# Service Information Letter

## Letter A-142

### **Turbocharger Installation and Turbine Housing Mounting Tab Shim Washers**

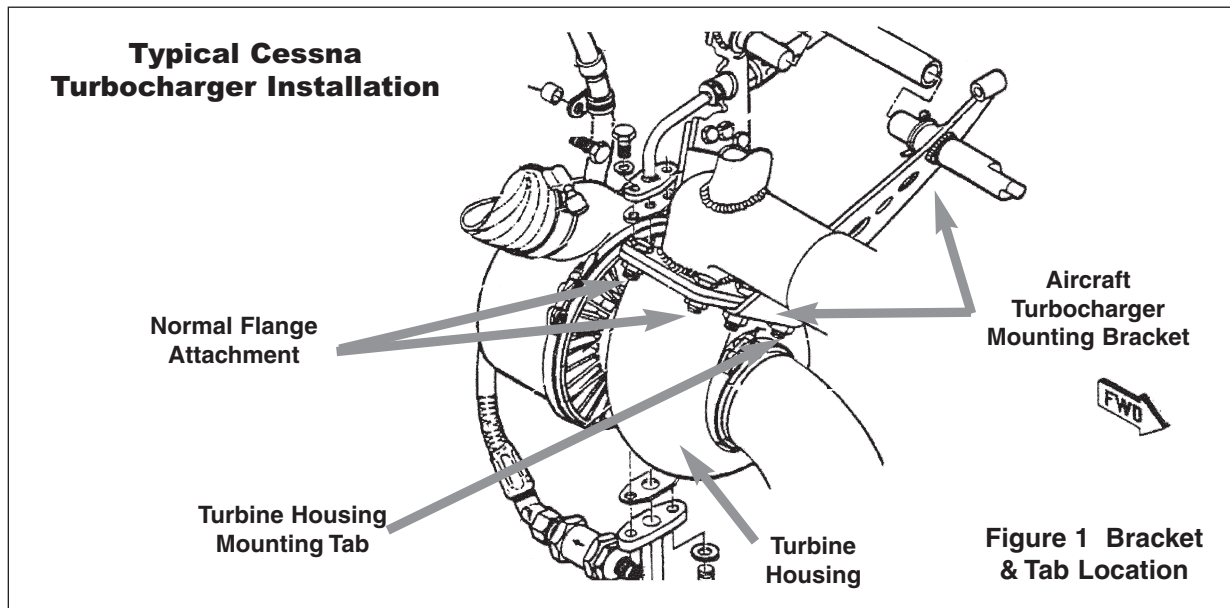
- (4) Begin the turbocharger installation per instructions found in the applicable section of the aircraft maintenance manual.
  - (a) Locate the interface between the aircraft turbocharger mounting bracket and the turbine housing mounting tab on the turbocharger installation. Refer to Figure 1.

Figure 2 - Gap at Flange & Tab

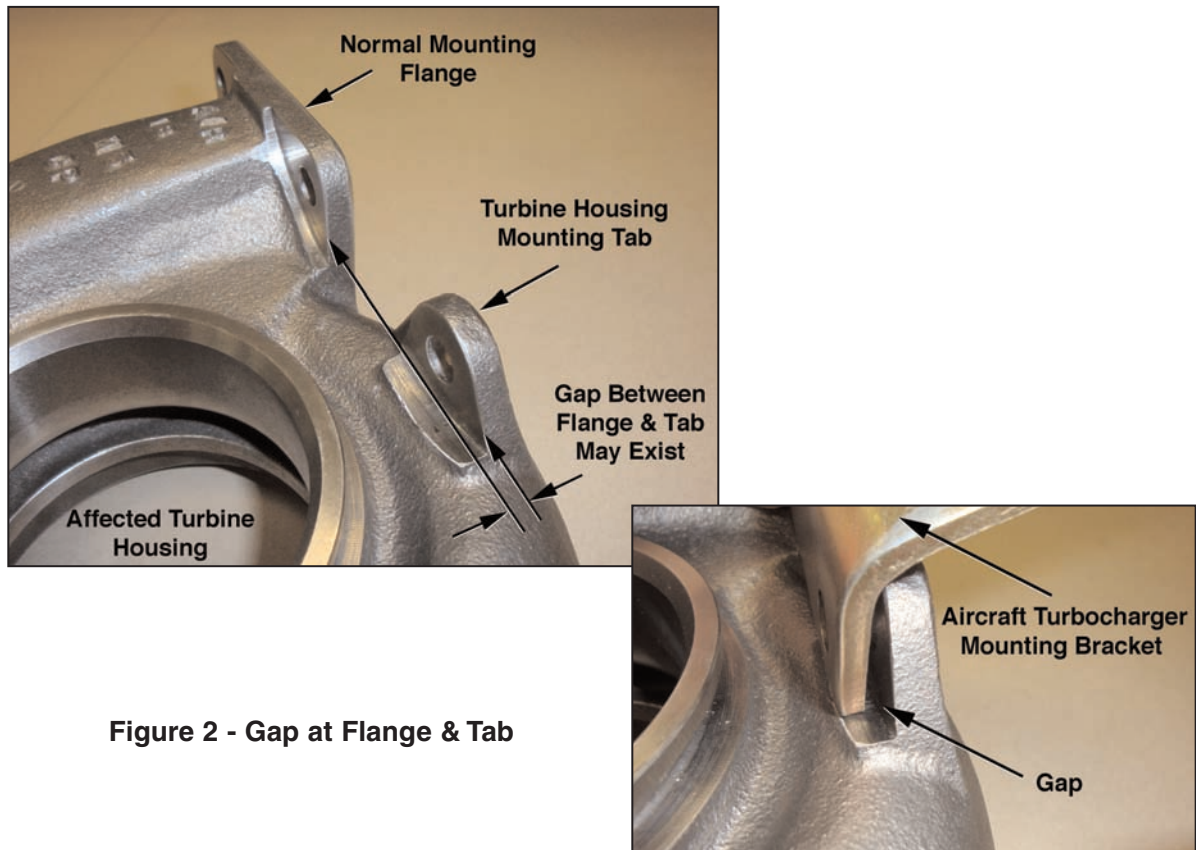
- (5) Identify if a gap exists in the installation.
- (a) The example in Figure 2 shows a removed turbine housing which has the turbine housing mounting tab location condition. Identify the turbine housing mounting tab location with respect to the normal mounting flange face. The tolerances in the machining of the turbine housing mounting tab (as well as other installation tolerances) may generate a gap that varies in size.

- (1) When installing the turbocharger, observe the initial fit of the turbine housing to the aircraft turbocharger mounting bracket. A gap at the turbine housing mounting tab to aircraft turbocharger mounting bracket must not exceed 0.015 inch.

**Figure 3 - In Plane Flange & Tab**

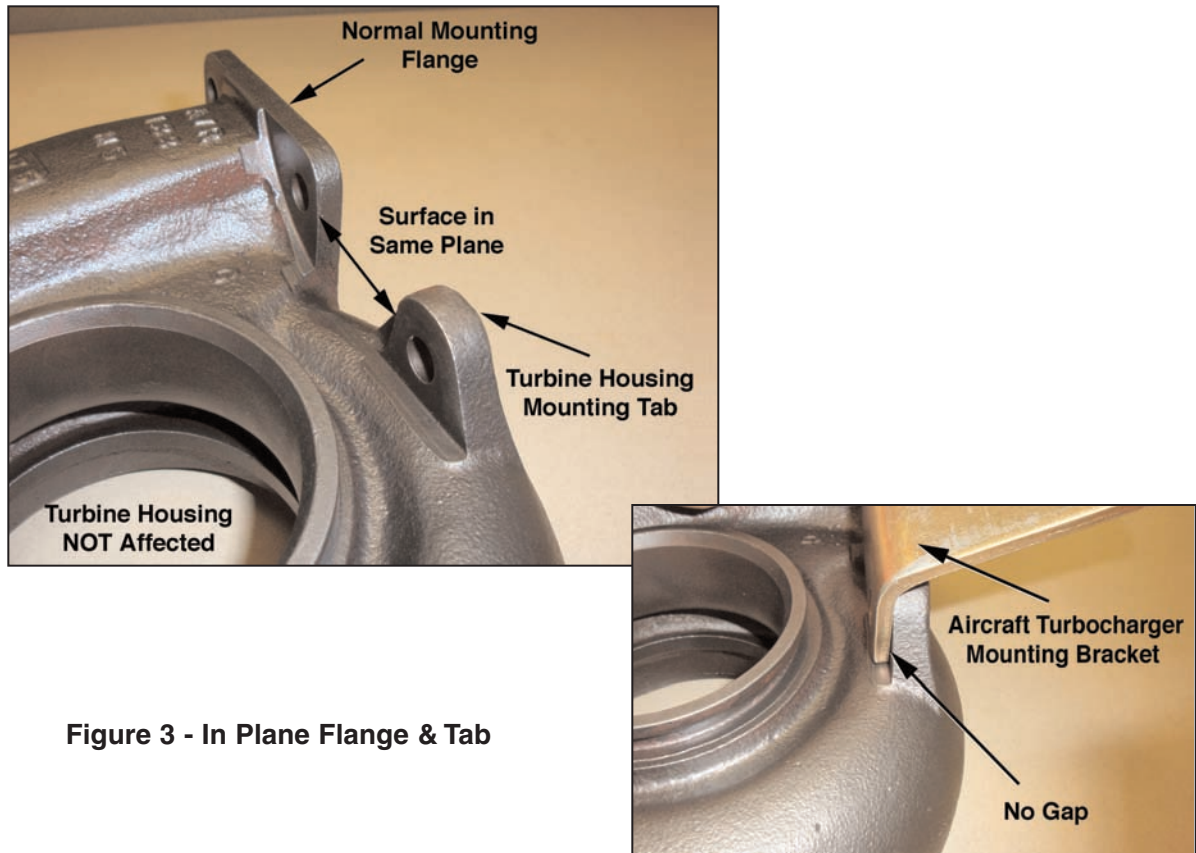
- (2) If the initial fit of the turbine housing to the aircraft turbocharger mounting bracket shows a gap 0.015 inch or less, continue with the normal installation procedures per the applicable section of the aircraft maintenance manual. See Figure 3.
  - (a) Upon successful completion of the aircraft turbocharger installation, proceed to "Return to Service" 3.D.(1).
- (3) If the initial fit of the turbine housing to the aircraft turbocharger mounting bracket shows a gap that exceeds 0.015 inch, continue with 3.C.(1)
